October 19, 2005

Re: Percolation Certification Plat  
Indian Hills, Lot 7

**PERCOLATION CERTIFICATION PLAN  
INDIAN HILL SUBDIVISION, LOT 7  
Tax Map 9, Parcel 136, Lot 7**

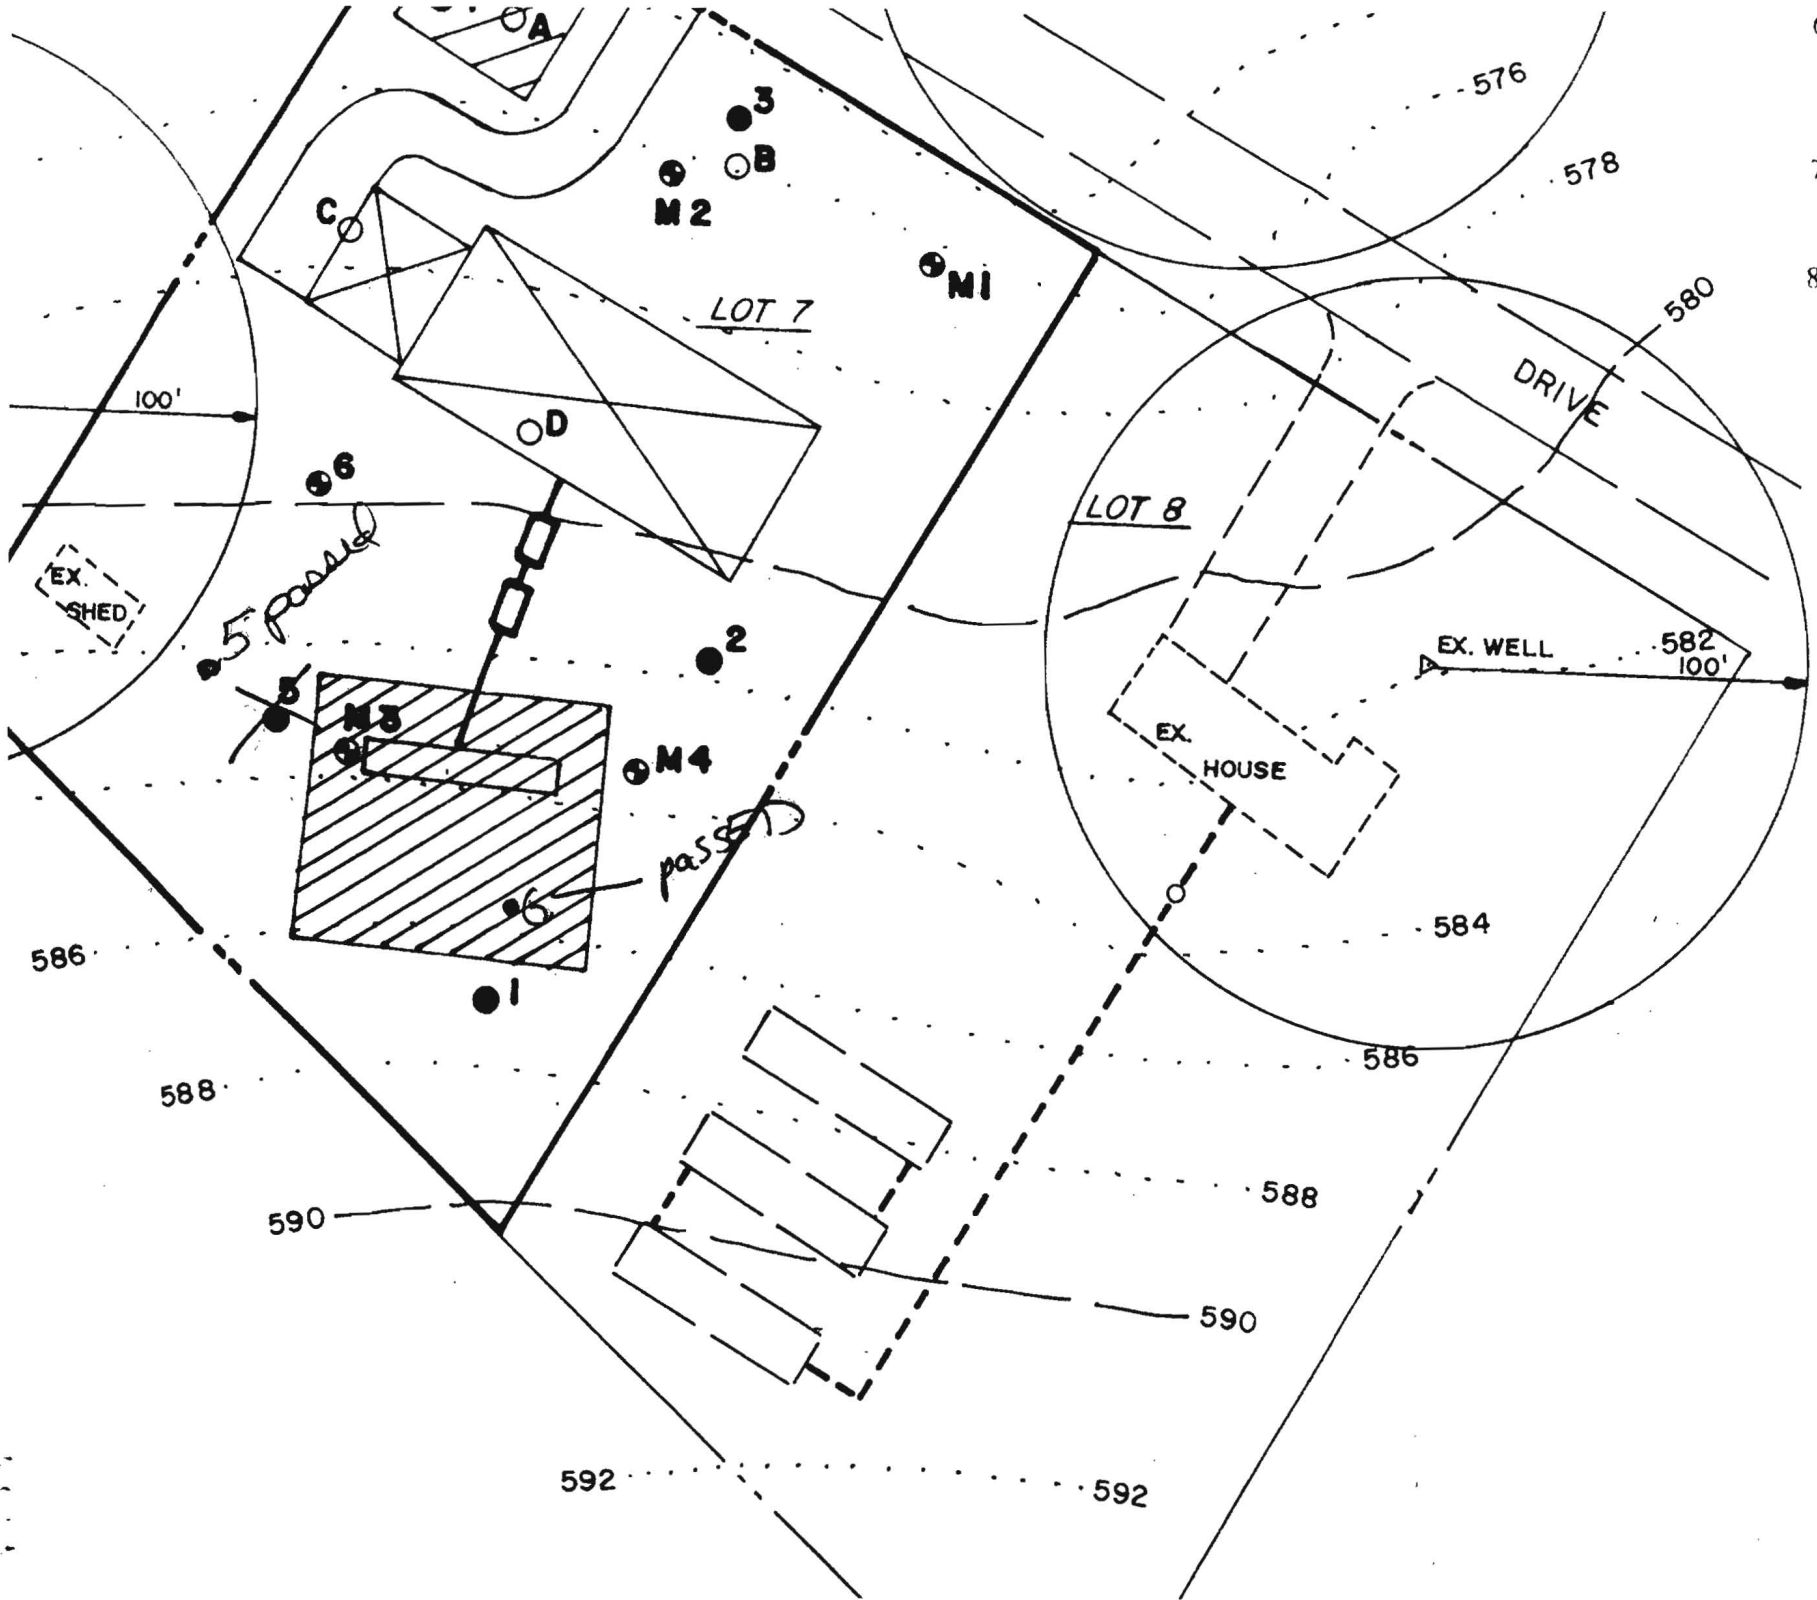
Our office reviewed the location of the percolation test holes on the percolation certification plat and found quite a few discrepancies. I can understand the confusion due to two different days and the labeling of holes the same. So, I took your hole labels, adjusted my perc notes to match and identified a few more holes that need to be added or adjusted. If you can make these changes so I can submit the plan back to Mike for signature, I think this will be the final round. He noticed the discrepancies with the holes so I have to ask for the adjustments. Just add them as I have shown, hole "G" and relocate hole #5.

LOT 6

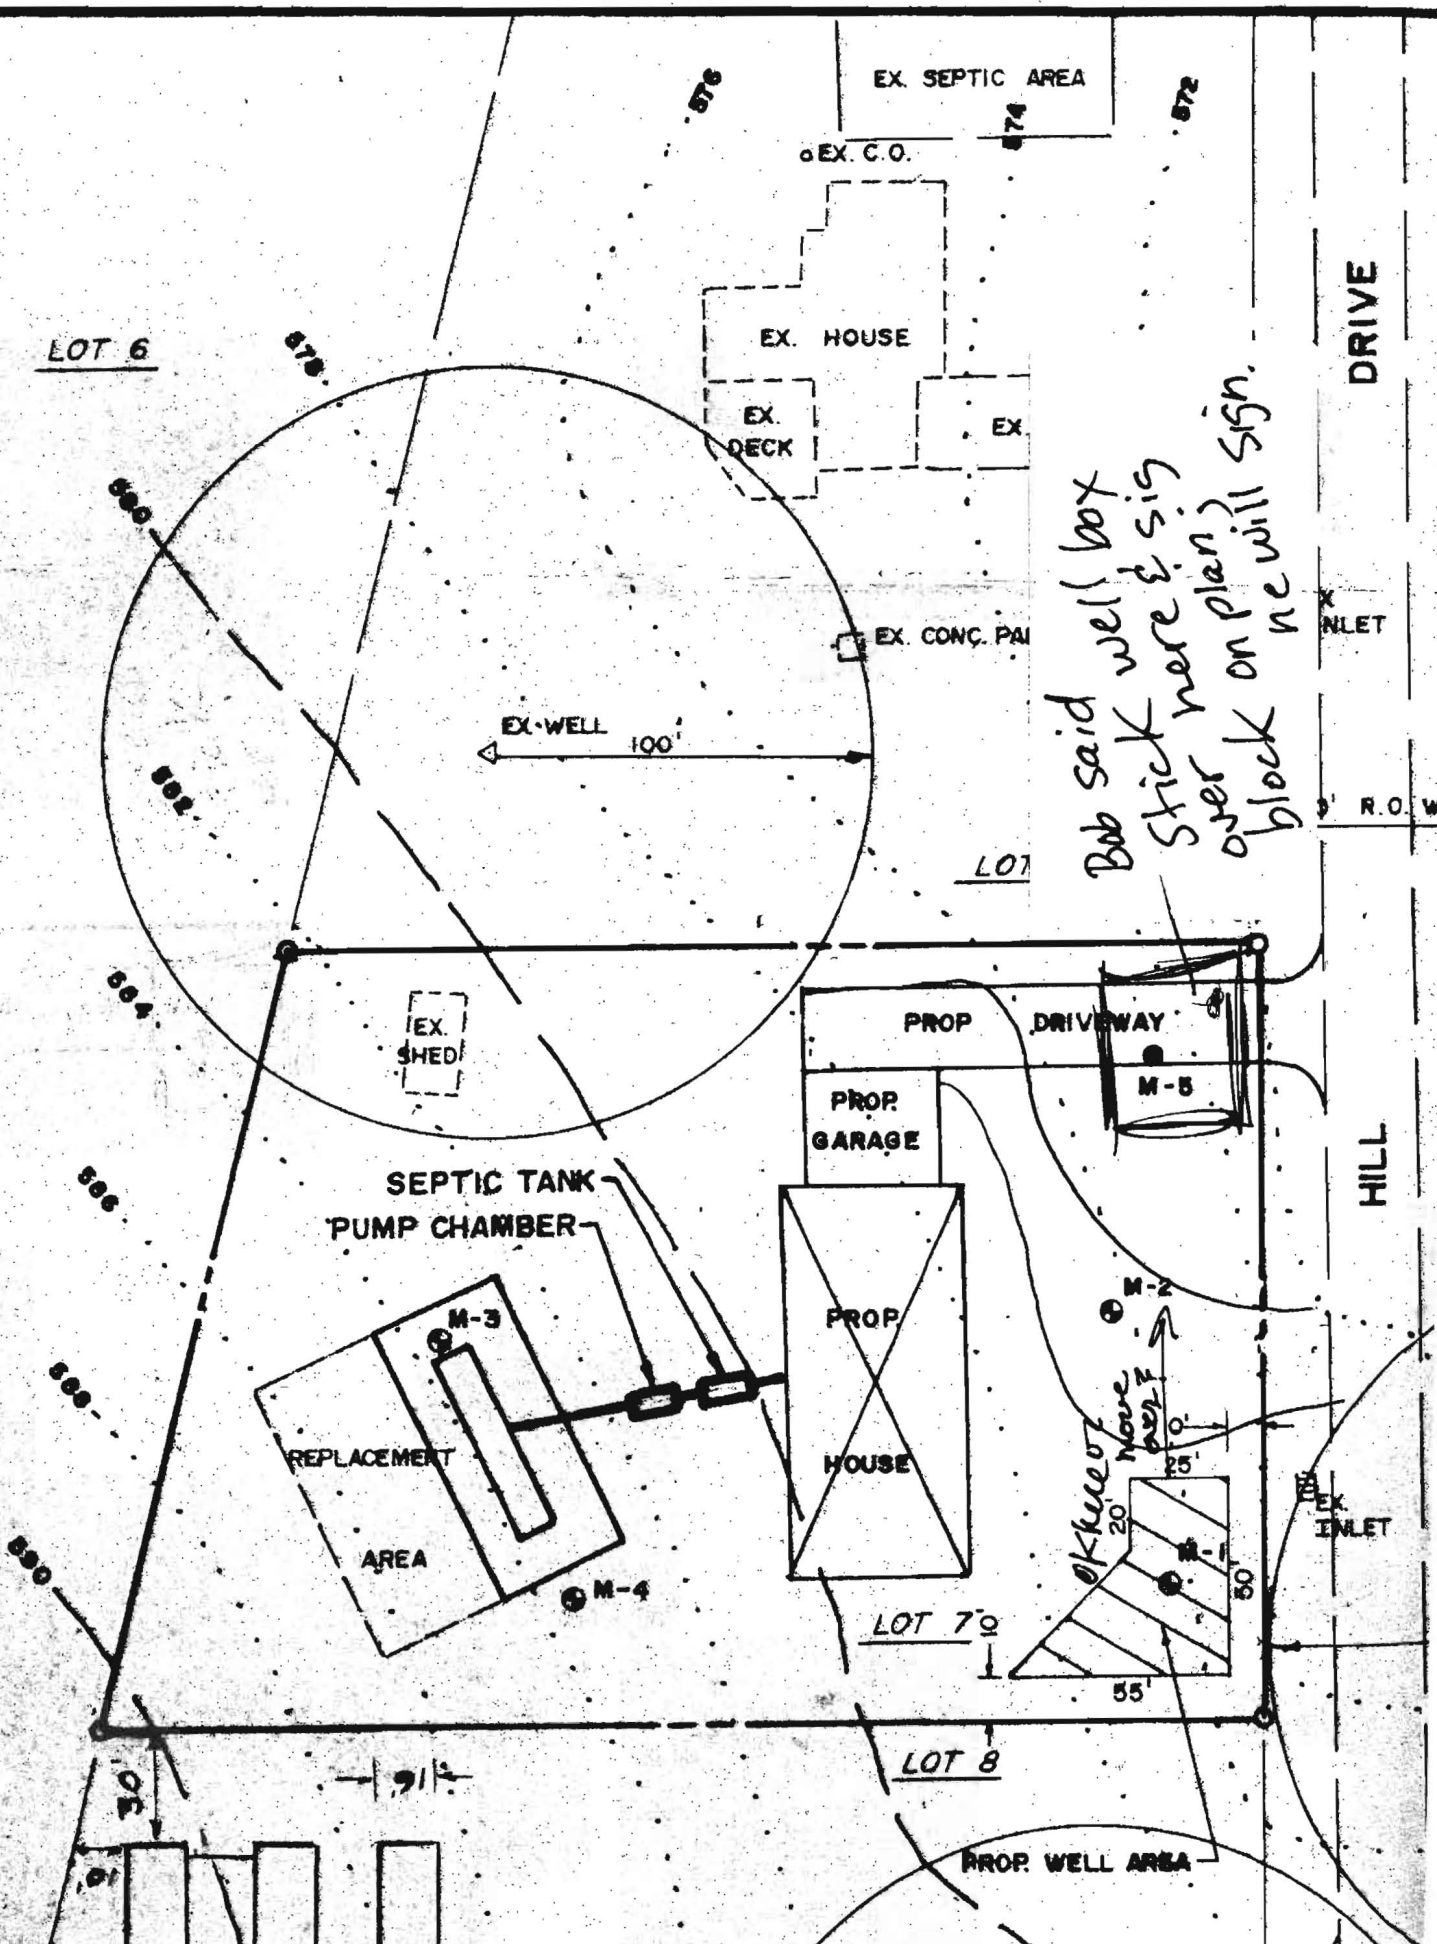
Bob said well box  
stick here & sig  
over on plan?  
ne will sign.

**SITE PLAN**  
SCALE: 1" = 50'

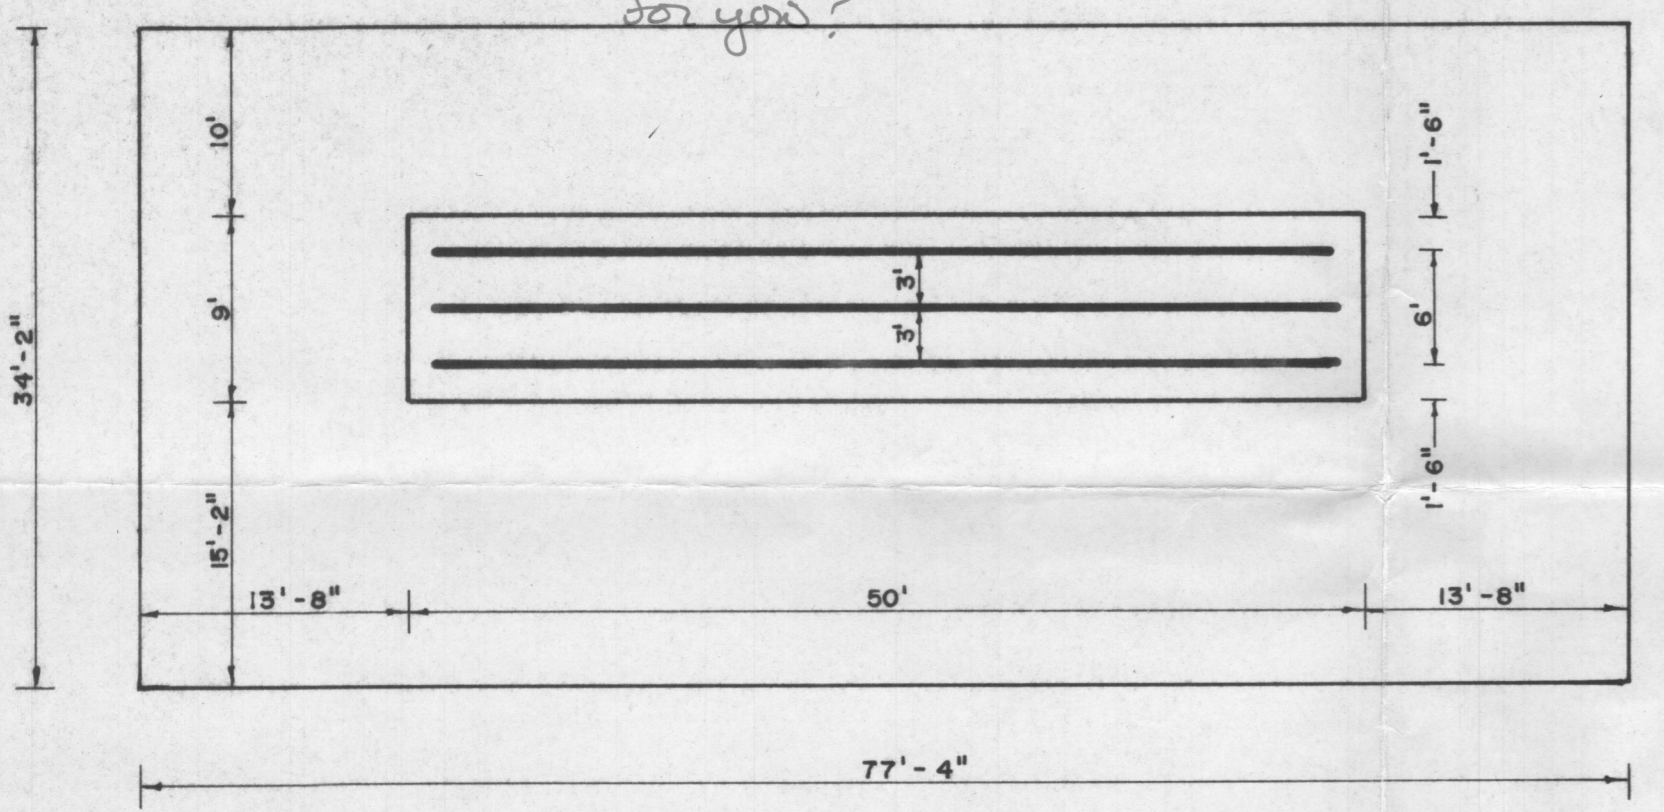
Future SDA where?

7/6/05  
Bob, tell me what you think. Need variance letter for spec, well conditions, or not? which corner works best for you?
